**Evaluation of HDR/SAWS
Modeling of the Carrizo-Wilcox Aquifer
in Lee, Bastrop, and Milam Counties, Texas**

George Rice
November 2001

Introduction

Figures C-1 through C-3 compare measured (historic) drawdowns in the Simsboro Aquifer to drawdowns estimated by the HDR model. The historic drawdowns represent changes in static water levels²¹. The numbers in parentheses represent cell locations (layer, row, column) in the HDR model.

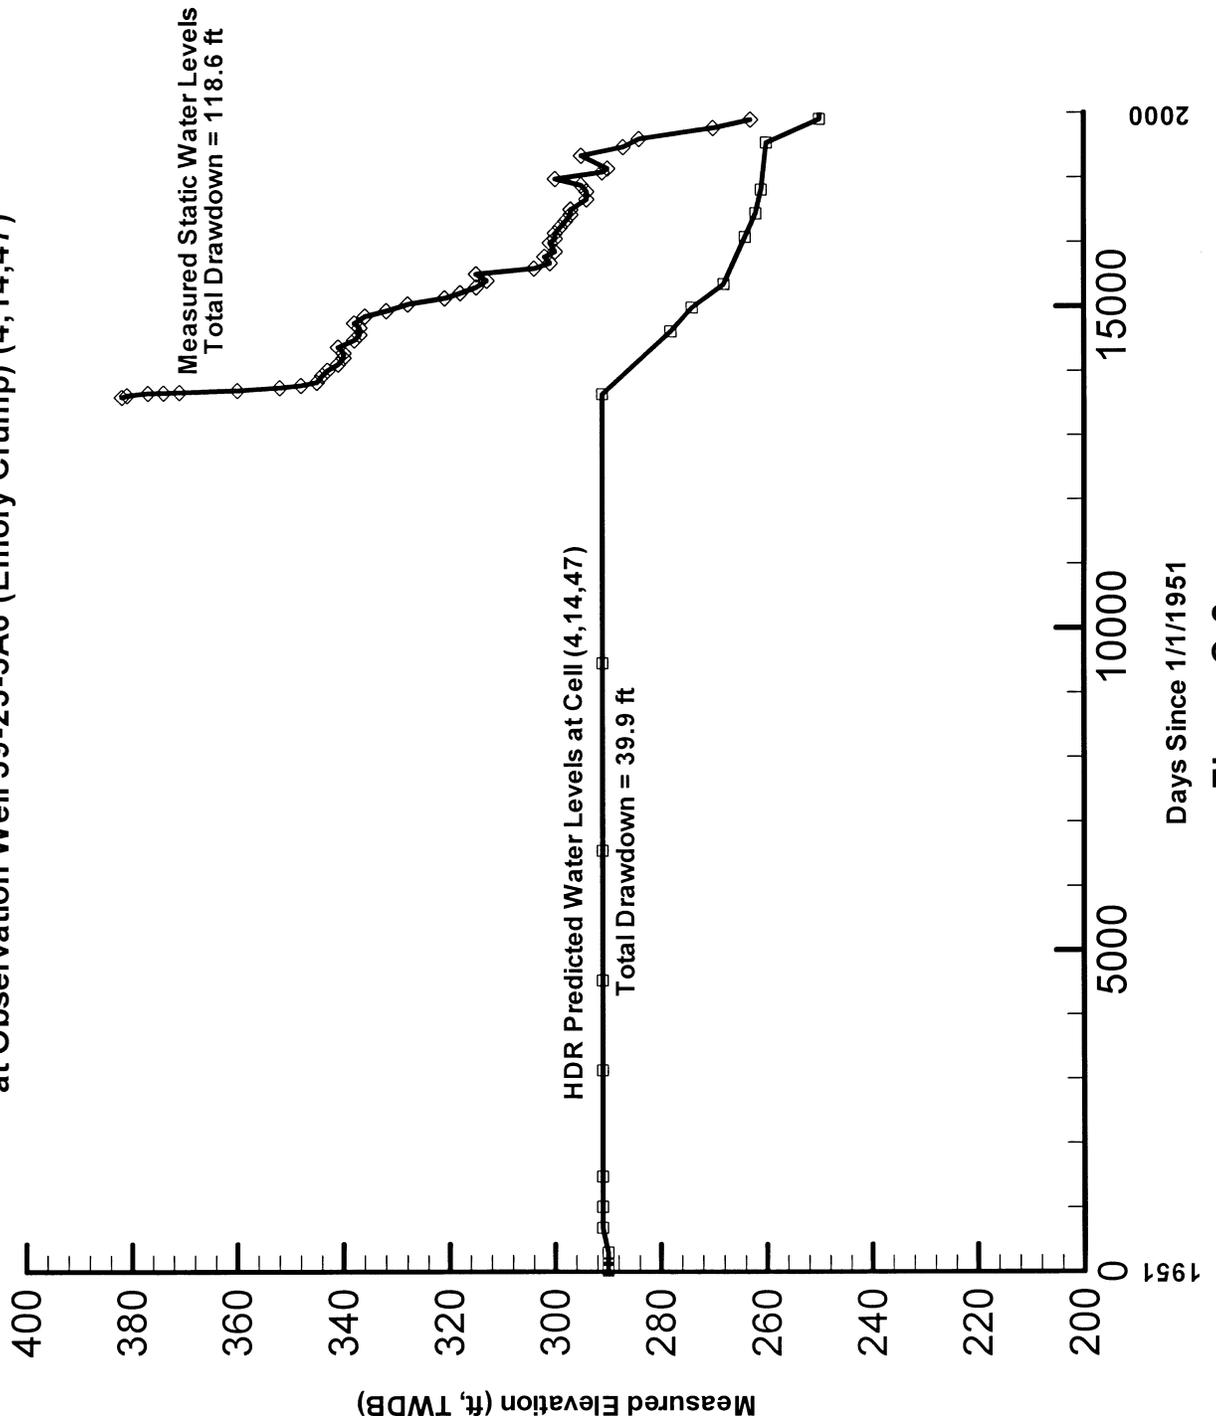
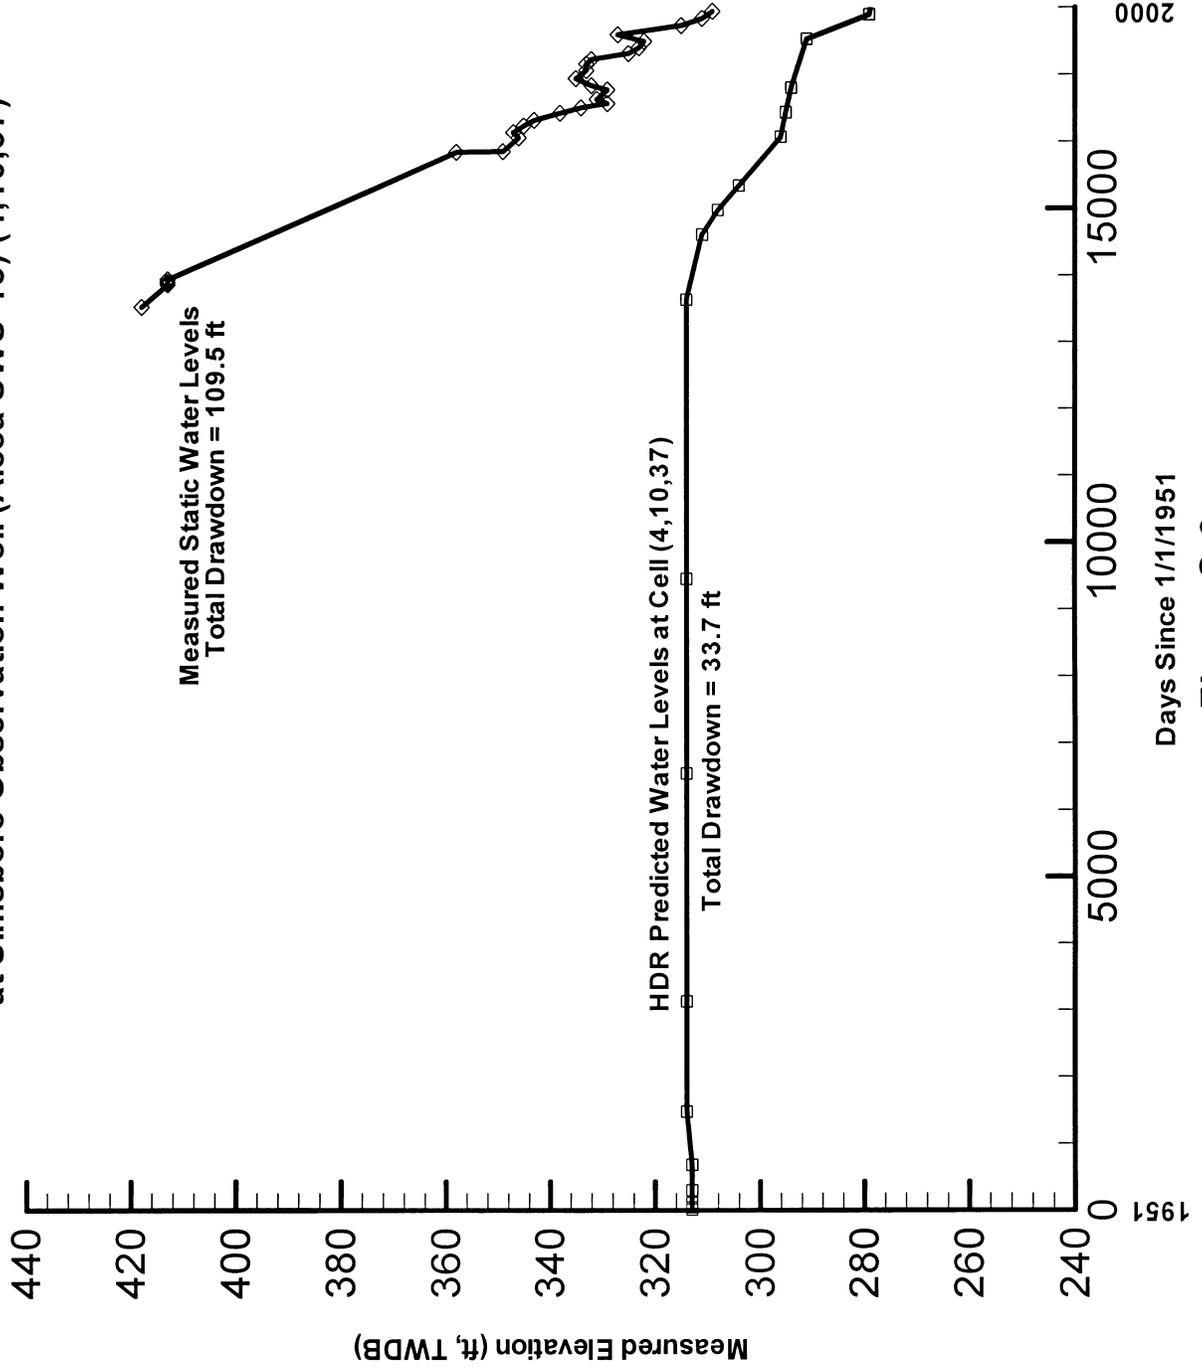
The HDR model under-estimates drawdowns that have already occurred. In some cases the model under-estimates measured (historic) drawdowns by a factor of more than three¹². The drawdown estimates are also significantly less than those produced by the Dutton model. The table below compares selected historic drawdowns to those estimated by the HDR and Dutton models. Figures in appendix C compare historic drawdowns in the Simsboro Aquifer to drawdowns estimated by the HDR model.

- The calibration period for the HDR model was from 1950 to 1997. Based on Dec 1997 water level measurements by ALCOA, the total drawdowns were 109 ft, 92 ft, and 85 ft instead of the reported 156 ft, 118 ft, and 109 ft for the historic record of the three referenced wells. In the Alcoa network of about 35 monitoring wells, it was not determined if these are representative wells or not, nor if the selected cells are the most appropriate ones for a comparison.

- The BEG and HDR models were designed to represent the regional system with one square mile cells and for long-term projections. The regional approach causes local details such as location of pumping wells and local aquifer features to be generalized. Likewise, the long-term simulations lead the modelers to smooth variable pumping rates over several years. As a result, the emphasis for calibration is not on individual wells located in areas where conditions are highly variable, but on wells with long-term data that are expected to reflect regional characteristics.

Figure D-1 shows the increases in Carrizo water levels predicted by the HDR model from 2000 to 2040. Figure D-2 shows the predicted increase in pumpage from the Carrizo Aquifer during this period. The pumpage data was taken from an HDR model input file.

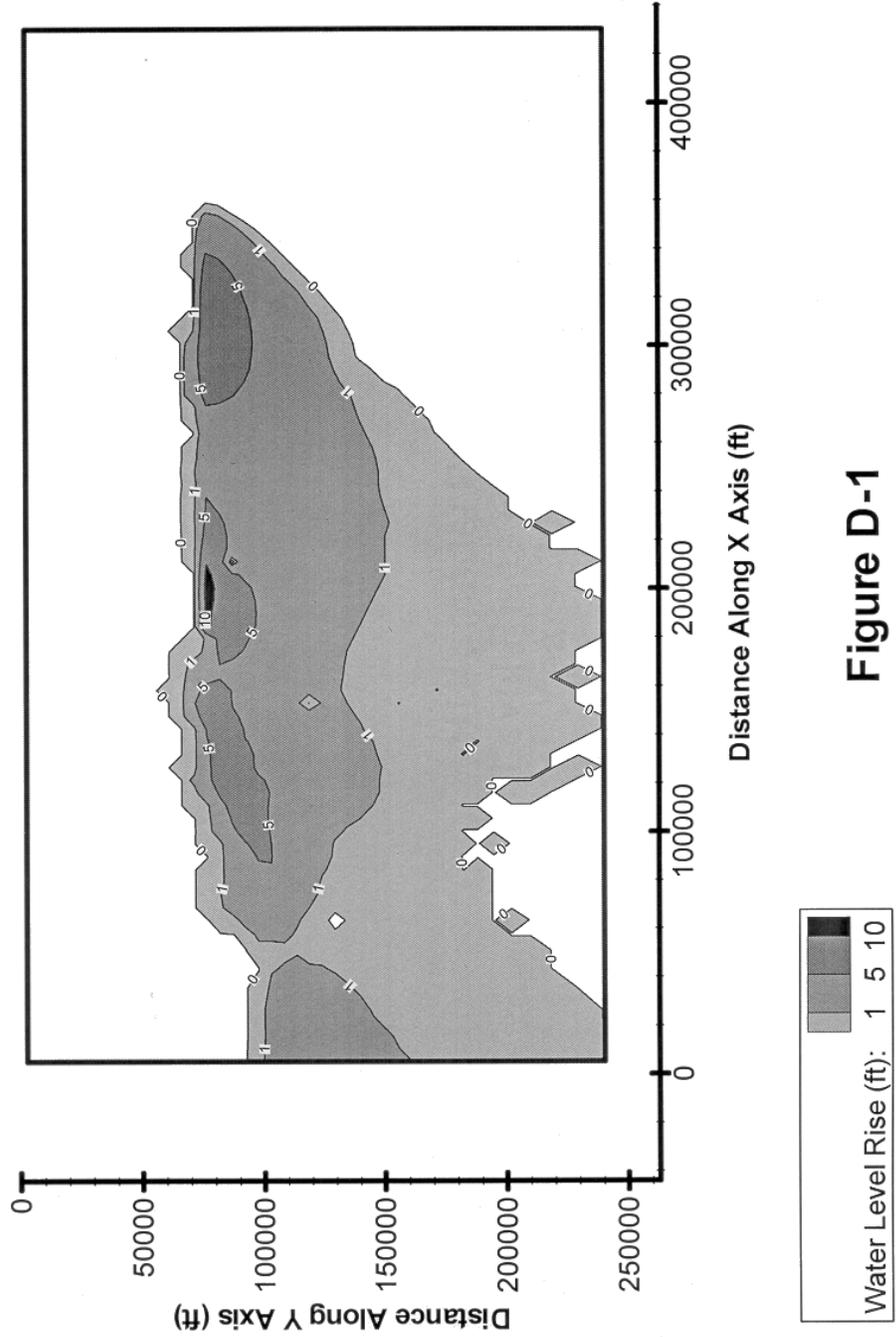
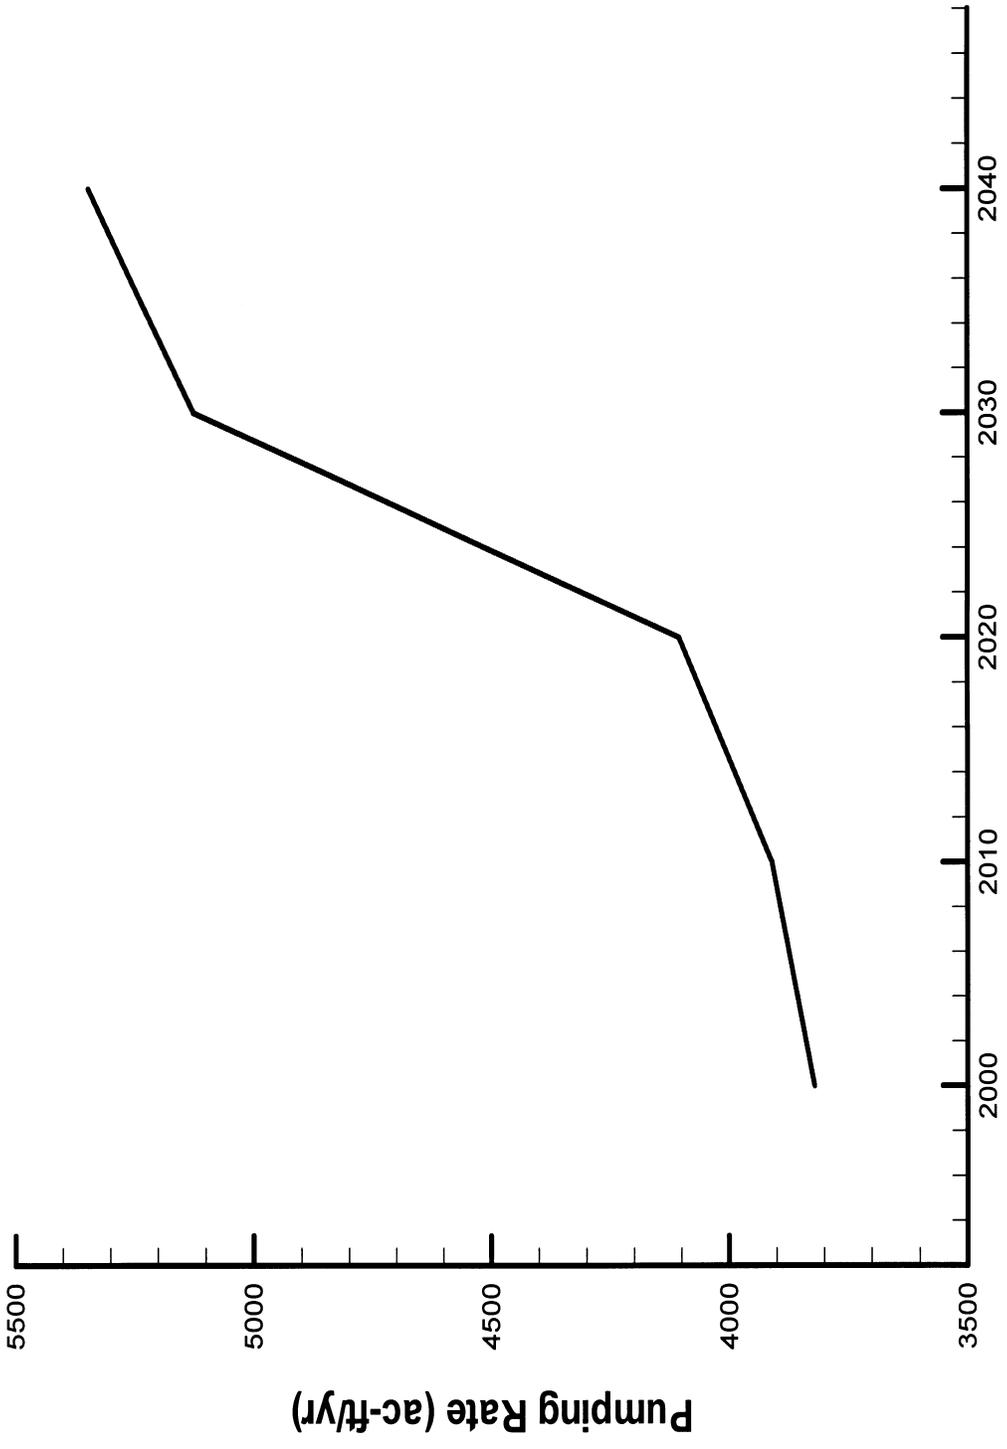
The HDR model predicts that water levels over most of the Carrizo Aquifer will rise between the years 2000 and 2040. This rise is predicted to occur even though pumpage increases from 3800 acre-feet/yr in 2000, to 5300 acre-feet/yr in 2040. Figures showing the increases in water levels and pumping rates are presented in appendix D.

In figure D-1 the X axis corresponds to the southeast boundary of the study area shown in figure 1. The Y axis corresponds to the southwest boundary of the study area.

- Water level gains initially shown in the model were a result of starting head elevations and land surface elevations that were initially set much too low near the updip limit of layer 1. Changes were applied and the model was rerun. The result was that water levels declined slightly (approximately 2 feet).
- Alcoa currently pumps approximately 30,000 acre feet per year with drawdown in the well field ranging between 75 – 150 feet. This is concentrated within the boundary of the Sandow Mine property and near the open mine. Pumping for SAWS Simsboro project will be spread over a greater area (~28 miles in length) and is therefore less concentrated. This is expected to result in much less drawdown.
